June 23, 2015

RE: Evaluation of the Work Plan and Supporting Documents for the Los Alamos (LA) County
Airport Landfill Cover Replacement, April 2015

Attached please find draft technical review comments on the above-referenced document. These comments were drafted by our subcontractor, TRM Environmental Consultants, LLC (TRM).

Figure 1. EPA-recommended cover design.

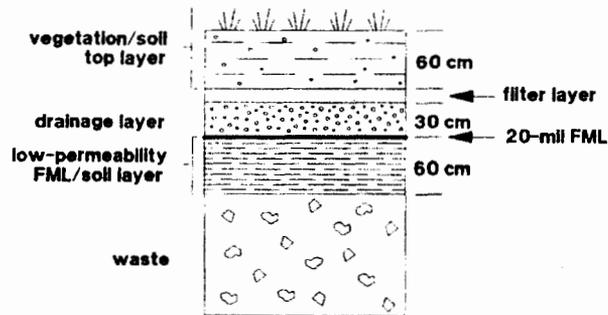
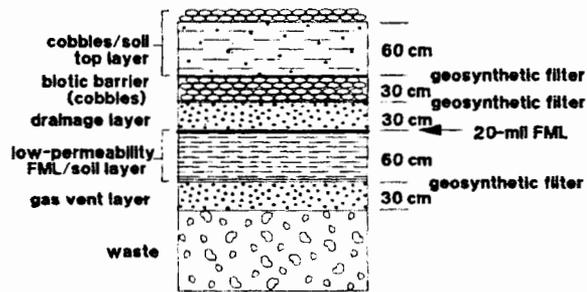
RCRA Subtitle C regulations also allow alternative designs that consider site-specific conditions including climate and the nature of the waste as long as the alternative design also meets the intent of the regulations, to protect human health and the environment (see 40 CFR § 264.301(b)). The Design Report should be revised to include a more detailed discussion of the regulatory requirements as they pertain to the Los Alamos County Airport Landfill Cover Replacement, which clearly indicate that use of the 40 CFR § 264.310 design criteria is considered an alternative design standard which requires substantiation and regulatory approval.
